**RE: Lot 2 Block 2 Unit 22 Volcano Cliffs SAD 228
8020 Canoncito Dr. NW
Grading and Drainage Plan
Engineers Stamp Date 2/13/17 (D10D003C2)**

**RE: Grading plan resubmittal (D10D0003C2)
8020 Canoncito NW**

ENGINEER'S SEAL 2/13/17	LOZOYA RESIDENCE 8020 CANONCITO DR NW	DRAWN BY: WCVJ DATE: 2-02-17
	GRADING AND DRAINAGE PLAN	21706-LAYOUT-2-01-17
 1606 CENTRAL AVENUE SE SUITE 201 ALBUQUERQUE, NM 87106 (505) 872-0999		SHEET # —
		JOB # 21706

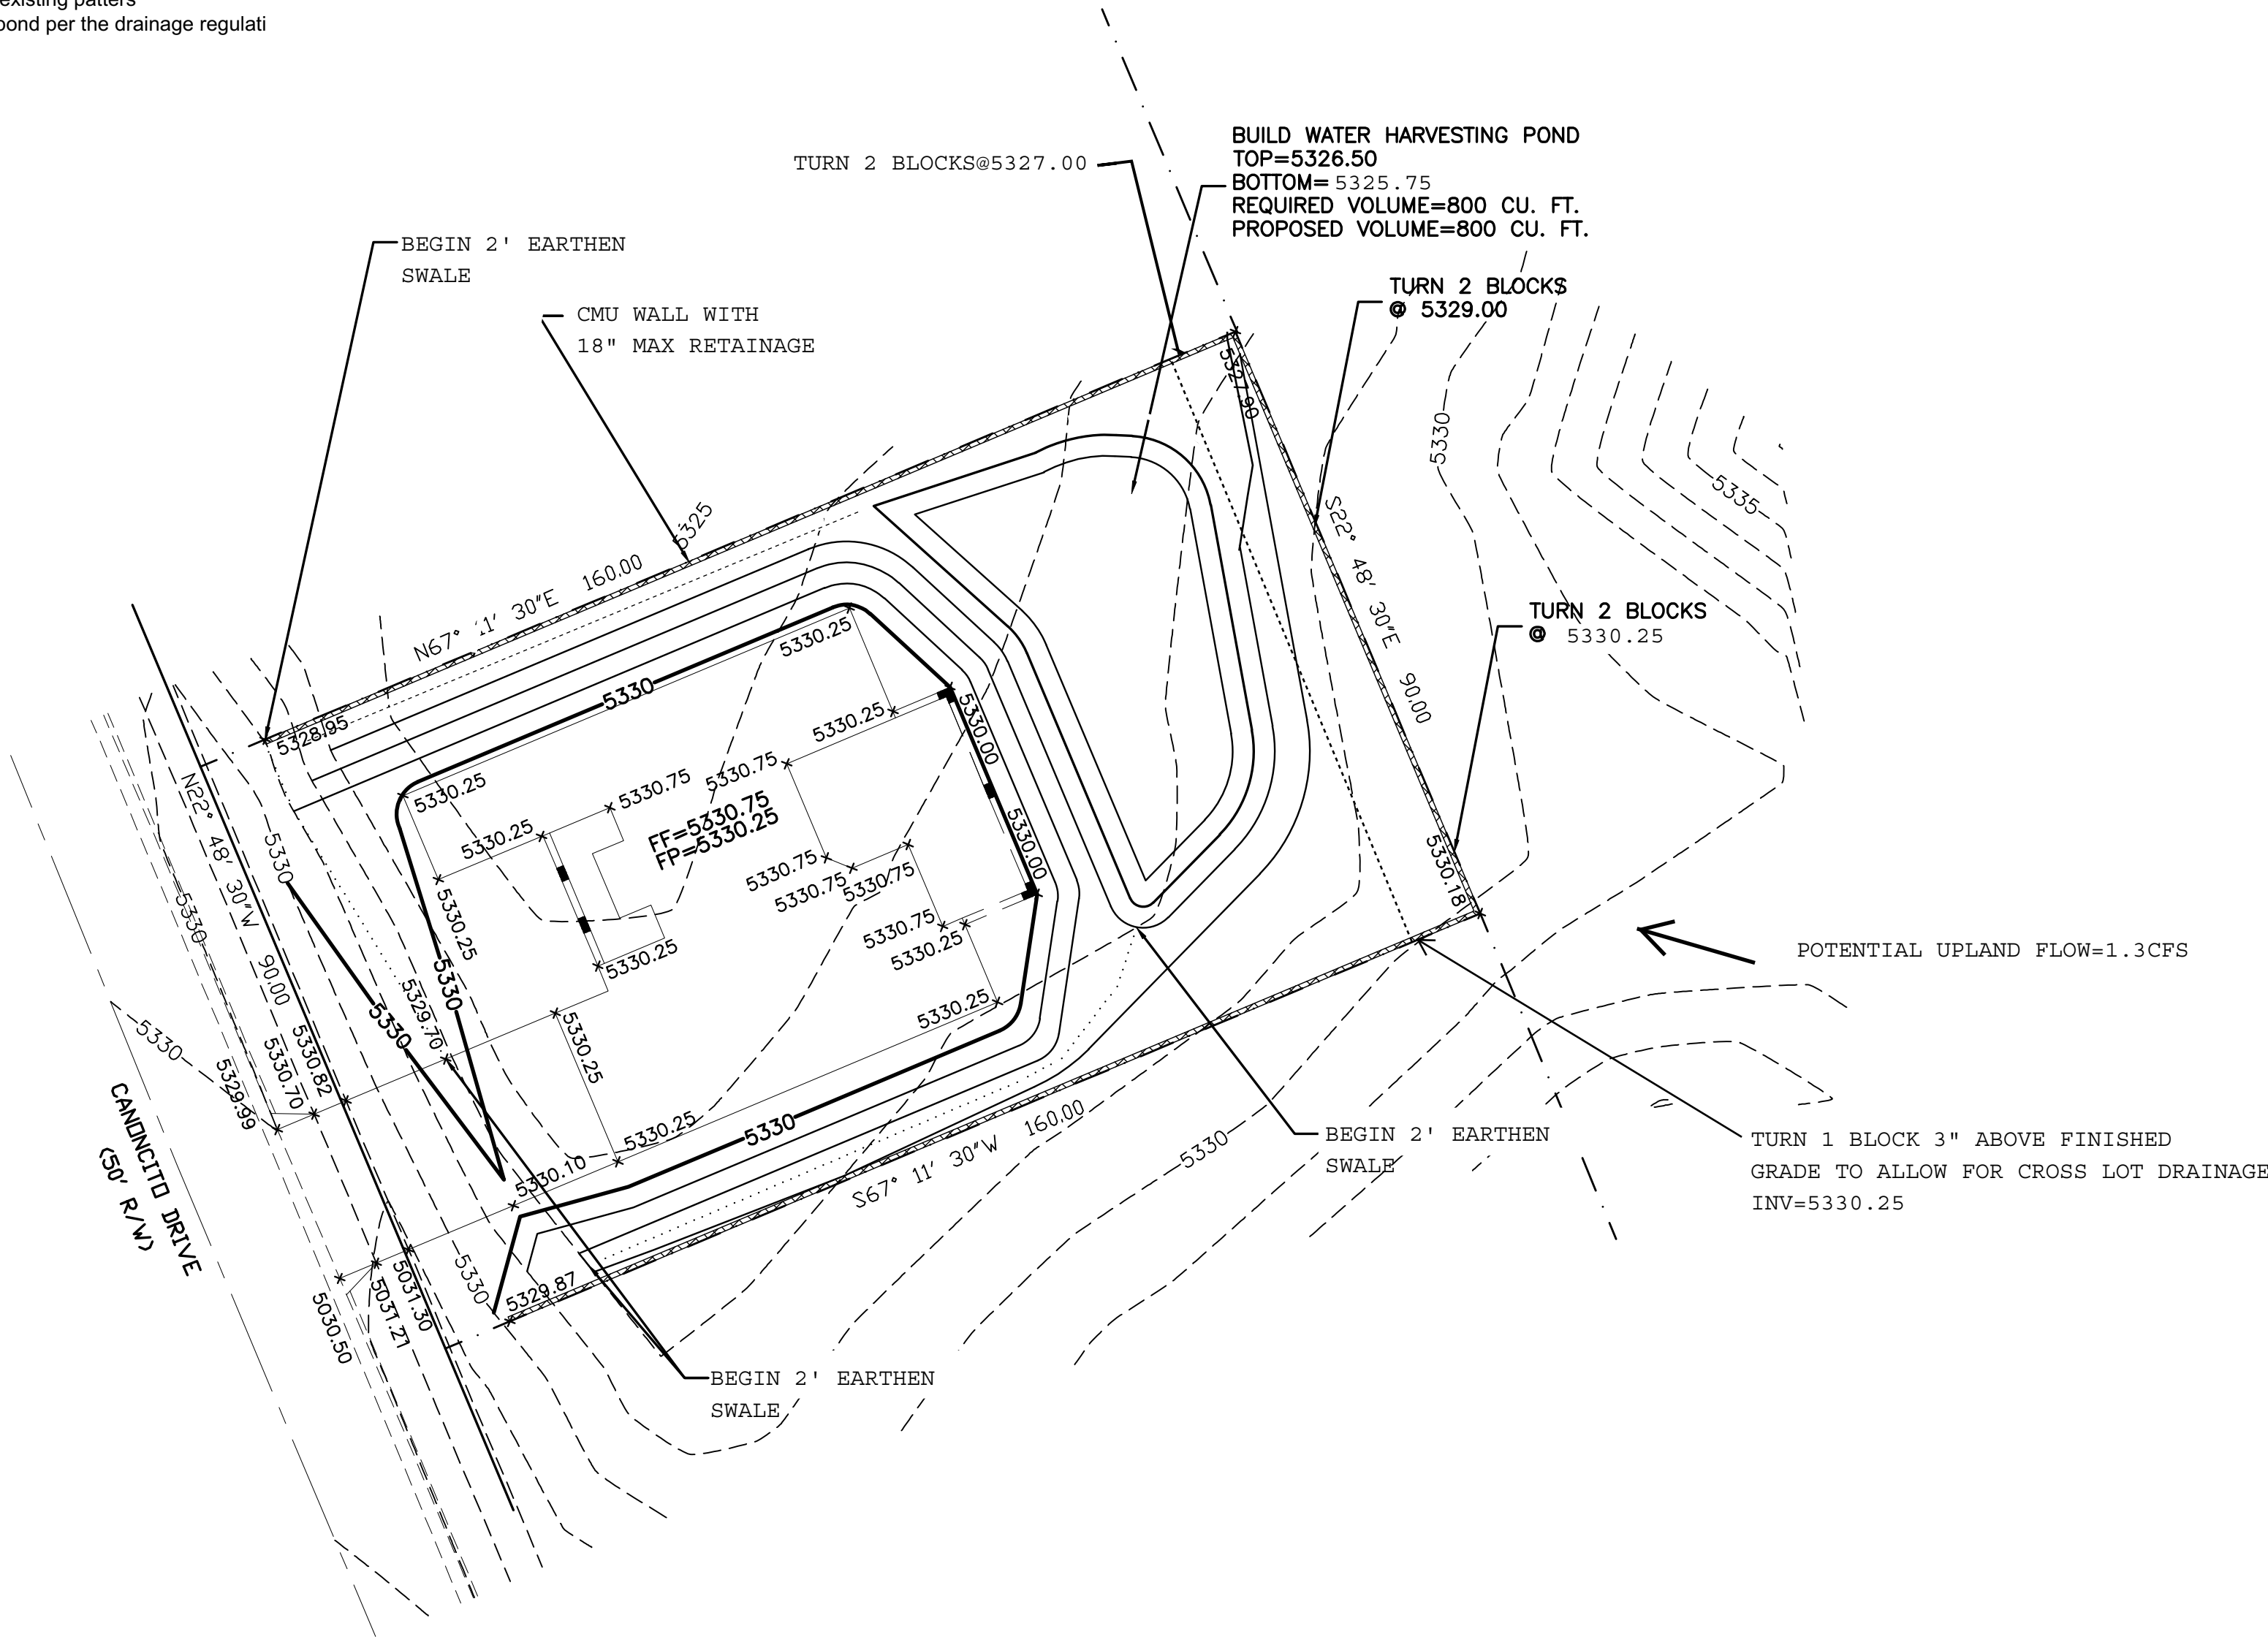
1. Place turned blocks within the rear 10' PUE

2. Show 10' PUE and place swale 1' away from wall

3. Place elevation at turned blocks

4. Provide statement regarding pad certification

5. Provide statement regarding block wall construction.

We have moved the blocks.

The existing grades do not lend themselves to place swale at the requested location.

We have forced the entry and exit point to that location but to place swale will required too much fill. The water will enter and leave at the prescribed locations

We have added

This has been added as note #4

This was described in note #3
